Petition No. 2020-044

Petitioner: Charlotte Planning, Design and Development

**AN ORDINANCE AMENDING APPENDIX A OF
THE CITY CODE –ZONING ORDINANCE**

~~15.6.5~~ 15.6.6 Buffer Yards

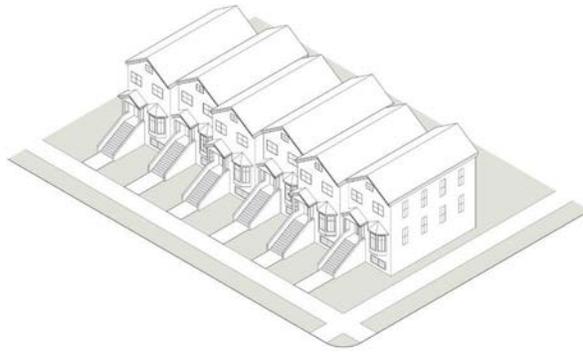
42. Amend Section 15.6.5, “Buffer Yards” by renumbering the subsection from 15.6.5 to 15.6.6. Revise subsection A to address unintended consequences, and revise subsections B and H for clarity. All other subsections remain unchanged. The revised Section number and subsections A, B, and H shall read as follows:

- A.** Buffer yards are required in setback zones abutting residential uses or vacant land in a single-family residential zoning district. This also applies along an alley with a right-of-way width of 25 feet or less that separates a TOD District from residential uses or vacant land in a single-family residential zoning district. However, property boundaries abutting a public park of three acres or more or a single-family residential zoning district containing two or fewer adjacent parcels are exempt from buffer yard requirements.

- B.** Buffer yards may be located within setback zones, but shall be reserved for the planting of material and installation of screening as required by this Section. No parking, stormwater facilities, accessory structures, or required on-site open space, shall be located in the buffer yard area. Stormwater facilities are permitted to cross a buffer yard perpendicularly.

- H.** A solid fence or wall, constructed of wood ~~or vinyl~~ posts and planks, brick, finished masonry, or stone, and a minimum of six feet and a maximum of eight feet in height shall be erected within six inches of the lot line along 100% of the buffer yard length, with the exception of ingress/egress points. The finished side of the fence, as opposed to the side with exposed structural supports, shall face the abutting property.

Multi-Family Attached Units

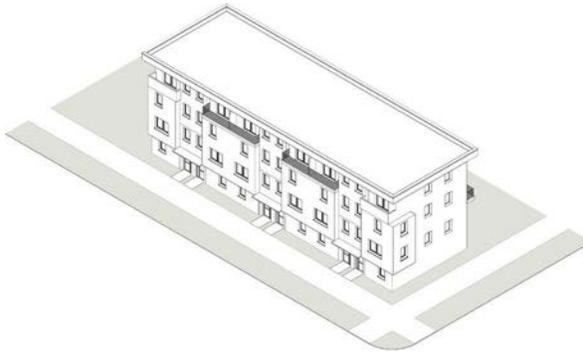
46. Amend Section 15.8.5, “Principal, Accessory, and Temporary Use Definitions”, by revising the definition of “Dwelling – Single-Family Attached”, and “Dwelling – Multi-Family Attached”. In addition, add the definitions for “Multi-Family Attached Unit” (and the graphic illustration) and “Multi-Family Stacked Unit” (and the graphic illustration) to this section [These are existing definitions in Section 15.13.2, being moved into Section 15.8.5, the correct Section.] The revised and added definitions shall read as follows:

- Multi-Family Attached Unit.** Attached unit design refers to multi-family residential designed as a structure with primary side-by-side units, each with an individual entry.

~~***Multi-Family Attached Units***~~

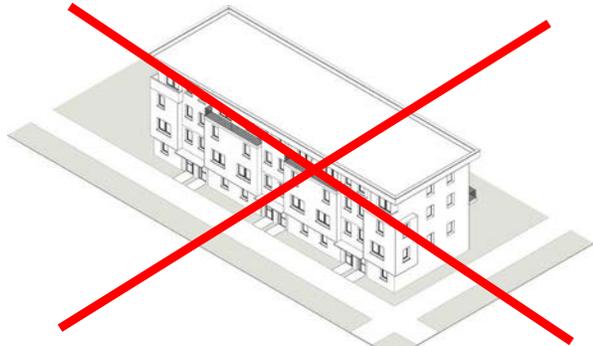
52. Amend Section 15.13.2 “Definitions” by 1) modifying the definition for “Blank Wall Upper Floor” , and deleting the associated graphic, and 2) deleting the definitions and graphics for “Multi-Family Attached Unit” and “Multi-Family Stacked Unit”. [These definitions and graphics are being relocated into Section 5.8.5.] The modified definition is as follows:

~~**Multi-Family Attached Unit.** Attached unit design refers to multi-family residential designed as a structure with primarily side-by-side dwelling units, each with an individual entry.~~
